RE: DCI2018-00003 The Pine Island 7-Eleven CPD

Below are responses to staff's comments related to the MCP in the staff report.

MASTER CONCEPT PLAN

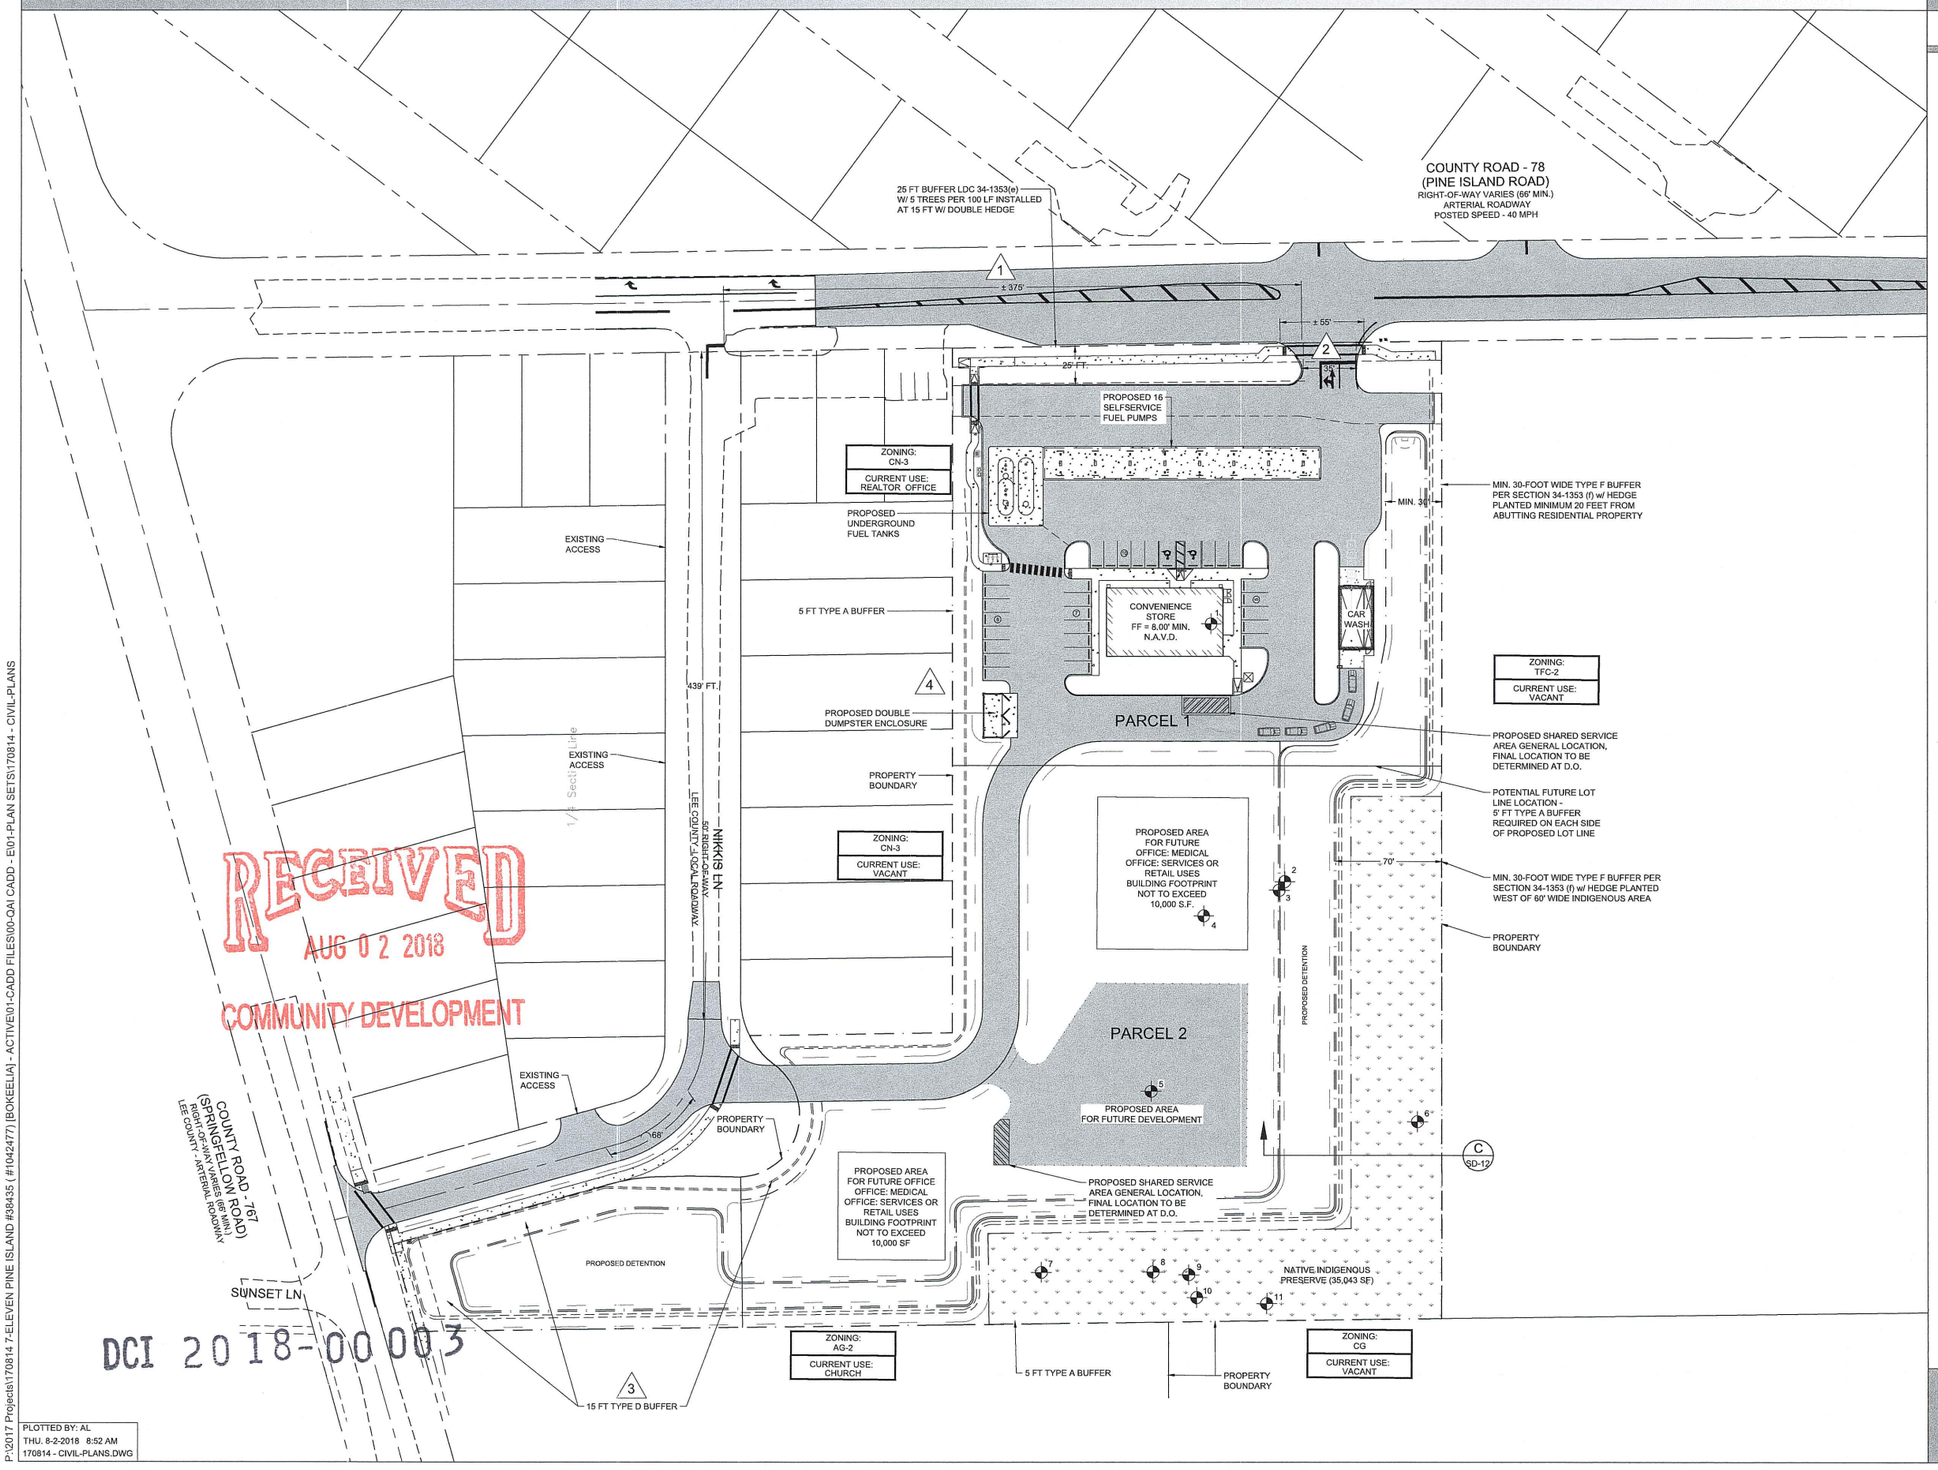
1. LDC Section 34-2013(b)(3) states development must have a distinct parking lot entrance meeting the requirements of Chapter 10. This Section also states the maximum width of the entrance at the property line cannot exceed 35 feet. The MCP shows the entrance on Pine Island Road. Although it is not dimensioned, the entrance appears to be substantially the same as shown on the local development order plans. These development order plans show the width is 55 feet wide.
   Deviation #2 has been added to address the driveway width.

2. LDC Section 34-1353 provides the supplemental regulations for convenience food and beverage stores, automobile service stations, fast food restaurants, and car washes. Subsection (f) states these uses must be separated from adjacent residentially zoned or developed properties by an eight-foot-high masonry wall or fence located 25 feet from the property line with the required landscaping, or a 30 foot wide Type "F" buffer with the hedge planted a minimum of 20 feet from the abutting property. The MCP along the eastern property line does demonstrate compliance with this Section of the LDC.
   The MCP has been clarified to show that the applicant proposes to construct a Type F buffer per Section 34-1353.

The MCP shows two parcels as part of this planned development. LDC Section 10-416 requires a buffer between two commercial lots or parcels. The MCP fails to show the required buffer. The MCP needs to be revised to show this required buffer.
   The MCP has been revised to show the requirement for the Type A buffer.

In review of the local development order plans, it should be noted the plans show only one parcel. If this remains true, the street right-of-way buffering required by LDC Section 34- 1353(e) must be demonstrated along Nikkis Lane and Stringfellow Road. The MCP should be revised to show compliance with this Section.
Deviation #3 has been added to request relief from Section 34-1353 regarding R/W buffers since the southern portion of the site's uses do not allow for uses addressed in this section.

3. LDC Section 10-295 states street stubs or an interconnection to adjoining areas must be provided where deemed necessary. The MCP shows no such proposed interconnection to the property to the east. Staff is concerned with public health and safety related to the design of the project and finds it would be appropriate to include future interconnection to the property to the east. The MCP should be revised to show an interconnection to the TFC-2 zoned property to the east.
The MCP has been revised to show the interconnection to the east and the west. However, we are asking for a deviation per John Malbacher to not have to provide an interconnect to the commercial parcels along our west property line.

4. LDC Section 34-373(a)j. requires the MCP to depict the proposed access and facilities for public transit in accordance with LDC Sections 34-411(e) and 10-442. The MCP needs to be revised to clearly depict this information.
A note has been placed on the MCP stating that we would comply with these sections of the code by providing the required improvements or by Fee-in-Lieu at the direction of Lee Tran.

1 DEVIATION #1 - LDC:10-285 PINE ISLAND ROAD SEPARATION, FROM A 440 FT REQUIRED CONNECTION SPACING TO PERMIT A 375 FT ± CONNECTION SPACING.

2 DEVIATION #2 - LDC:34-2013(b)(3) ACCESS, TO INCREASE MAXIMUM DRIVEWAY WIDTH AT THE PROPERTY LINE FROM 35 FEET TO 55 FEET.

3 DEVIATION #3 - PROVIDE R/W BUFFERS ADJACENT TO NIKKIS LANE AND STRINGFELLOW ROAD IN ACCORDANCE WITH LDC SECTION 10-416 ONLY AND BE EXEMPT FROM COMPLIANCE WITH LDC:104-1353(e) FOR THESE TWO ROADS.

4 DEVIATION #4 - LDC:10-295 STREET STUBS TO PROVIDE INTERCONNECTION TO PARCELS ADJACENT TO PINE ISLAND ROAD BUT NOT COMMERCIAL LOTS ON NIKKIS ROAD.

IN ACCORDANCE WITH SECTIONS 34-411(e), 10-442 & 10-443, APPLICANT SHALL PROVIDE THE REQUIRED IMPROVEMENTS OR PROVIDE A FEE-IN-LIEU AS DIRECTED BY LEE TRAN
